Access Compliance Report

Public Rights-of-Way

Intersection ID: N/A	Main Street: BRECKFIELD_CT	Cross Street: KIRKWYND_COMMONS_DR	Location: NE
ADA ID: 9154789C3455	Ramp Type: PerpDiag	Initial Pass/Fail: Fail	Overall Compliance: No
Codes/Mitigation Info/Possible Solution		Field Measurements/Component Compliance

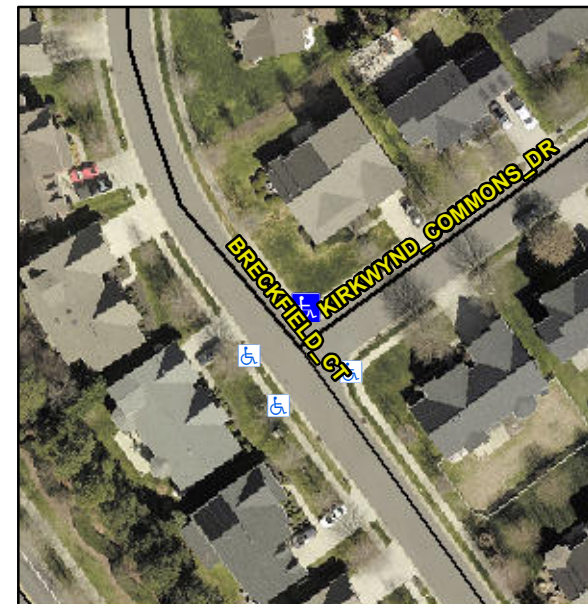
R304.5.1, R304.2.2, R304.5.3

Compliance	Description	Data	Compliance	Description	Data
N/A	Ramp Length (in)	46.0	No	Ramp Slope (%)	9.0
No	Ramp Width (in)	47.0	No	Ramp XSlope (%)	4.0
N/A	Flare Type LT	N/A	N/A	Flare Type RT	N/A
N/A	Flare Slope LT (%)	N/A	N/A	Flare Slope RT (%)	N/A
N/A	Flare Traversable LT?	N/A	N/A	Flare Traversable RT?	N/A
N/A	Landing Length (in)	N/A	N/A	DWS Provided?	N/A
N/A	Landing Width (in)	N/A	N/A	DWS Contrast?	N/A
N/A	Landing Slope (%)	N/A	N/A	DWS Length (in)	N/A
N/A	Landing X Slope (%)	N/A	N/A	DWS Full Width?	N/A
N/A	Landing Curb? (Y/N)	N/A	N/A	DWS Offset (in)	N/A
N/A	Shared Landing?	N/A			
N/A	Gutter Ponding?	N/A	N/A	Gutter Slope (%)	N/A
N/A	Gutter Lip Ht (in)	N/A	N/A	Gutter X Slope (%)	N/A
N/A	Painted X Walk1?	No	N/A	Painted X Walk2?	No
	X Walk 1 Direction	To SW		X Walk 2 Direction	To SE
N/A	X Walk 1 Width (in)	N/A	N/A	X Walk 2 Width (in)	N/A
	X Walk 1 Slope (%)	1.4		X Walk 2 Slope (%)	1.6
	X Walk 1 X Slope (%)	1.8		X Walk 2 X Slope (%)	0.3

Remove & Replace Curb Ramp With Two New Directional Ramps or Equivalent.
